REQUEST

Current Zoning: R-3 (single family residential)
Proposed Zoning: R-8MF(CD) (multi-family residential, conditional)

SUMMARY OF PETITION

STAFF RECOMMENDATION

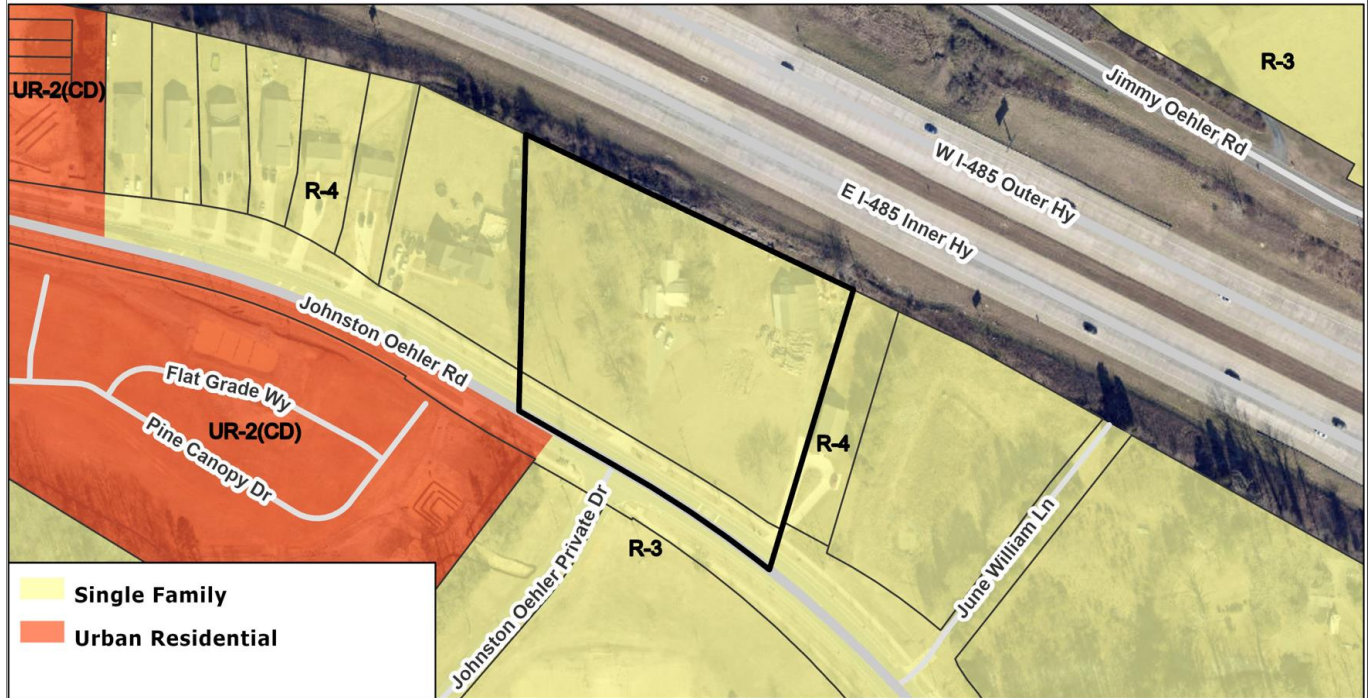
1. Part of what is shown would not qualify as protected tree save. This will either need to be adjusted to protect existing trees and/or additional tree save would be required. **Update:** Petitioner must show acceptable tree save on rezoning plan. Replanted tree save is not an available option.

7. **New Comment:** The driveway connection to parcel 02962162 would not be allowed because parcel 02962162 is zoned R-4. Planned multi-family developments cannot be accessed through R-4 zoning.

Parcel 02962162 would need to be rezoned to a district that allows for Planned multi-family developments to allow for the driveway connection.
